ORIGINATION FORM

Proposed Revisions to a Standard Plans Index (Please provide all information — Incomplete forms will be returned)

Index Number: 515-070

Index Title: Pipe Guiderail (Aluminum)

TYPICAL SECTION ON CONCRETE SIDEWALK

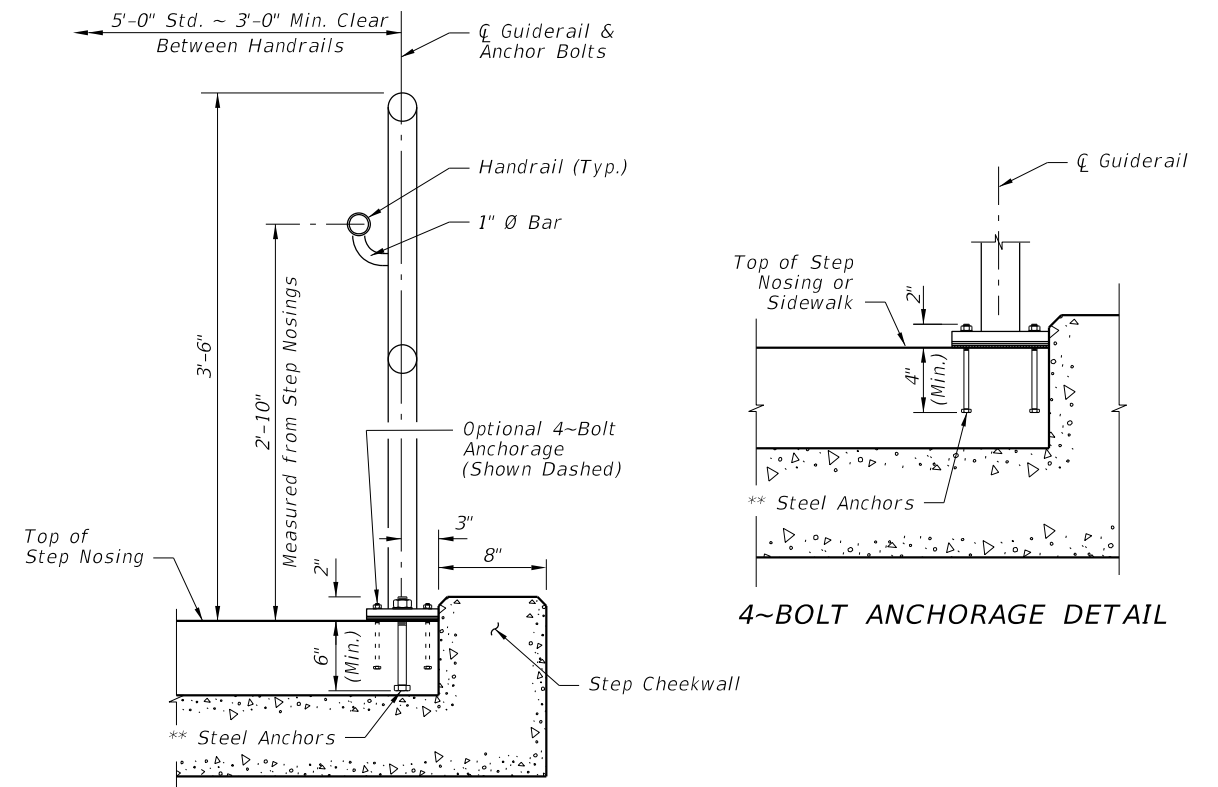
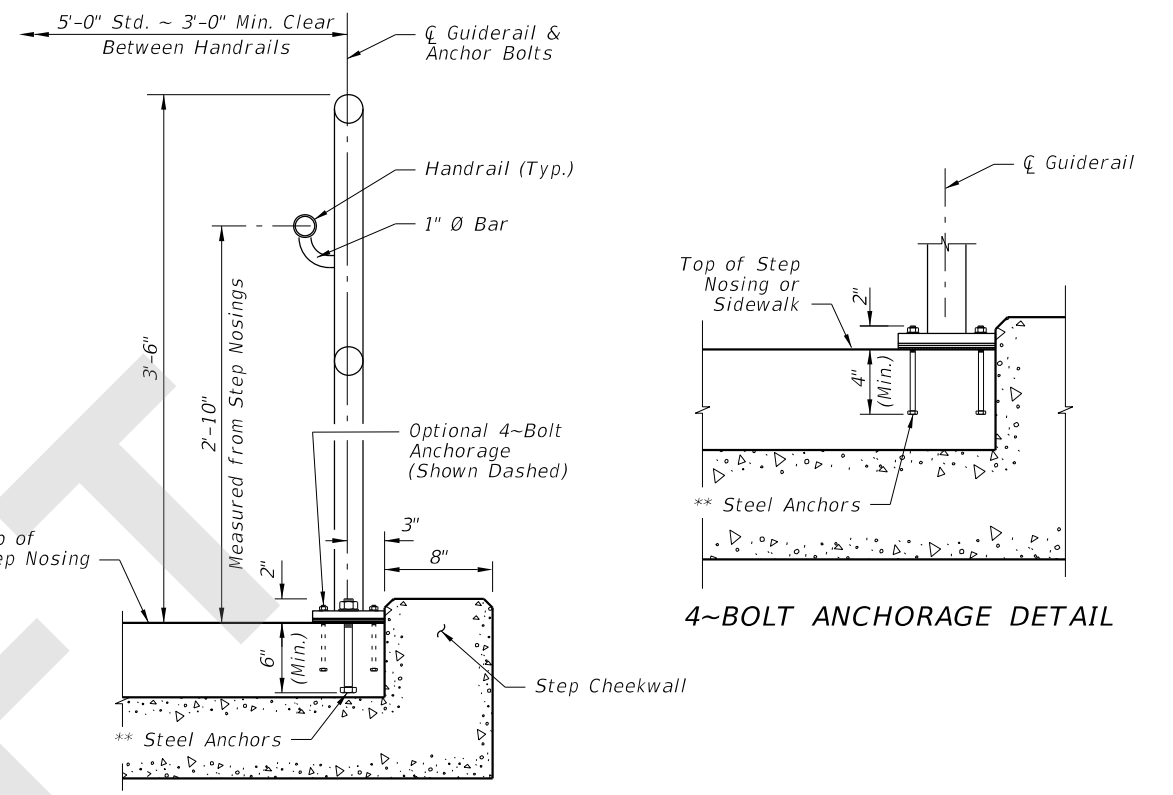
Change edge beam of sidewalk to 9" deep.

Due to research, embedment was reduced to 6"; therefore, the depth can be reduced to 9".
